SERVICE BULLETIN

SUBJECT TS-940S TRANSMITTER HUM IN SSB

DATE
9-15-86

IF UNIT (X48-1430-00)

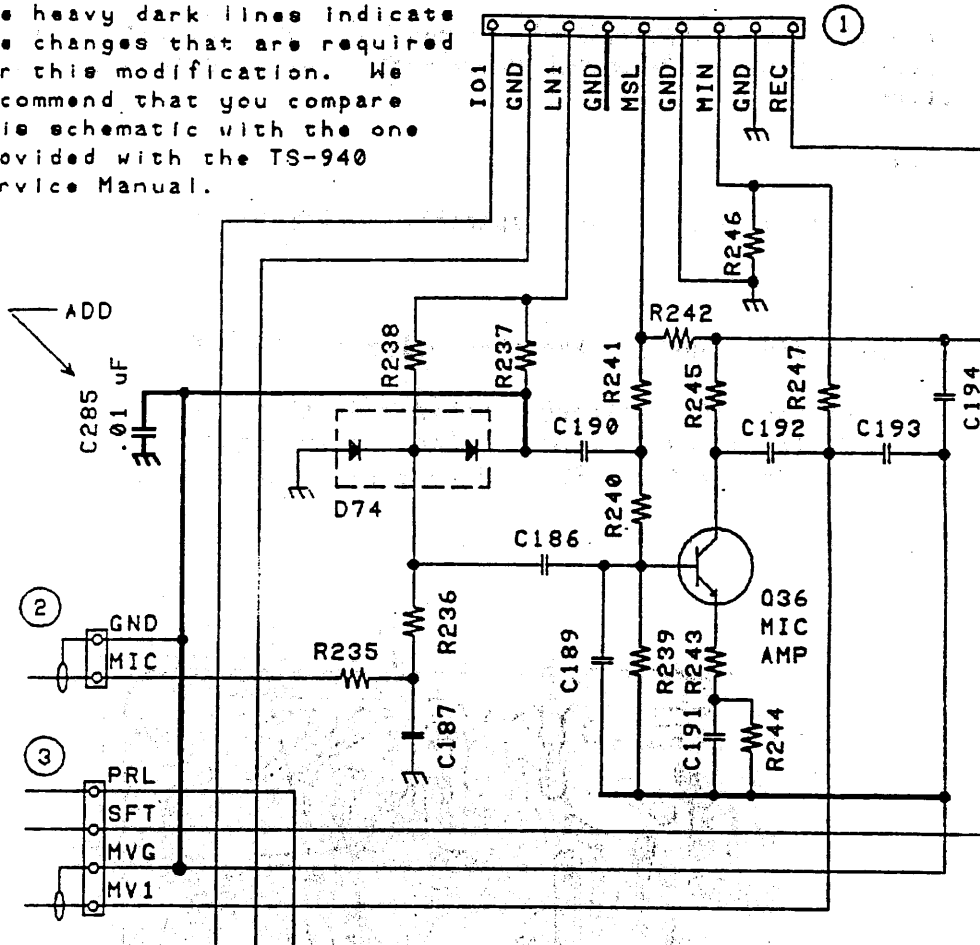
On the IF UNIT (X48-1430-00) make the following changes:

- Cut the foil patterns labeled A-E in figure 1.
- Add the jumpers wires labeled F-H in figure 1.
- Add capacitor C285 .01 uF 50 v as shown.

The heavy dark lines indicate the changes that are required for this modification. We recommend that you compare this schematic with the one provided with the TS-940 Service Manual.
